# Access Compliance Report

## Public Rights-of-Way

### (Curb Ramps)

Intersection ID: 23825	Main Street: LOBLOLLY_LN	Cross Street: LONGLEAF_DR	Location: SE
ADA ID: E18FBB00E5AD	Ramp Type: Directional1	Initial Pass/Fail: Fail	Overall Compliance: No
Severity Score: 13.75			
Codes/Mitigation Info/Possible Solution		Field Measurements/Component Compliance

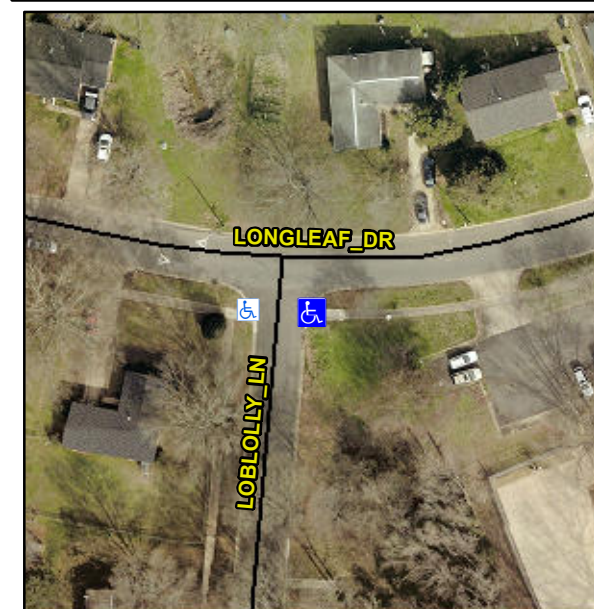
**R304.2.2, R304.5.3**

Compliance	Description	Data	Compliance	Description	Data
N/A	Ramp Length (in)	117.0	N/A	Grade Break?	N/A
Yes	Ramp Width (in)	56.0	N/A	Grade Break Slope (%)	0.0
No	Ramp Slope (%)	9.4	N/A	Grade Break XSlope (%)	0.0
No	Ramp XSlope (%)	4.3			
N/A	Flare Type LT	N/A	N/A	Flare Type RT	N/A
N/A	Flare Slope LT (%)	N/A	N/A	Flare Slope RT (%)	0.0
N/A	Flare Traversable LT?	N/A	N/A	Flare Traversable RT?	N/A
N/A	Landing Length (in)	0.0	N/A	DWS Provided?	N/A
N/A	Landing Width (in)	0.0	N/A	DWS Contrast?	N/A
N/A	Landing Slope (%)	0.0	N/A	DWS Length (in)	N/A
N/A	Landing X Slope (%)	0.0	N/A	DWS Full Width?	N/A
N/A	Landing Curb? (Y/N)	N/A	N/A	DWS Offset LT (in)	N/A
N/A	Shared Landing?	N/A	N/A	DWS Offset RT (in)	N/A
N/A	Gutter Ponding?	0.0	N/A	Gutter Slope (%)	N/A
N/A	Gutter Lip Ht (in)	0.0	N/A	Gutter X Slope (%)	N/A
N/A	Painted X Walk1?	No		Road Slope (%)	1.1
	X Walk 1 Direction	To W		Road X Slope (%)	4.4
	X Walk 1 Width (in)	N/A		Clear Space?	N/A

X Walk 1 Slope (%)	1.1	N/A	Clear Space to XWalk (in)	N/A
	X Walk 1 X Slope (%)	4.4	N/A	Storm Grate/Utility Hazard?	N/A
N/A	Ramp inside XWalk1?	N/A		Storm Grate/Utility Type	
N/A	Any Obstructions?	N/A			N/A
	Obstruction Type		Yes	Surface Condition? (G/P)	Good
			N/A	Curb Slope (%)	13.0

**Remove & Replace Entire Ramp.**
